# TECHNICAL PROCEDURE

## TRAILER SUSPENSION SYSTEMS

**SUBJECT:** Plumbing the New  
Three-way Push / Pull Valve

**LIT NO:** L1146

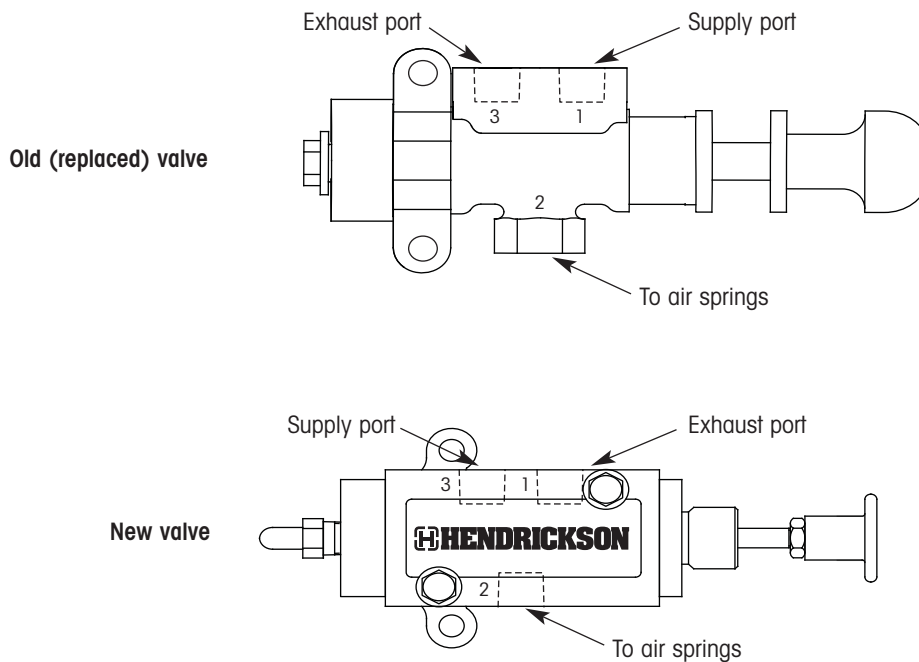
Earlier this year, Hendrickson Trailer Suspension Systems introduced a new three-way push / pull valve to replace the one used in AK-147 and AK-148 manual dump kits. At that time, the new valve was described as identical to the one being replaced. Although the valve functions properly, it has come to our attention that the new valve plumbing orientation is not identical to the "old" valve.

**For the handle operation to remain consistent with the old valve, the exhaust must be plumbed to the port closest to the handle on the new valve as shown below.**
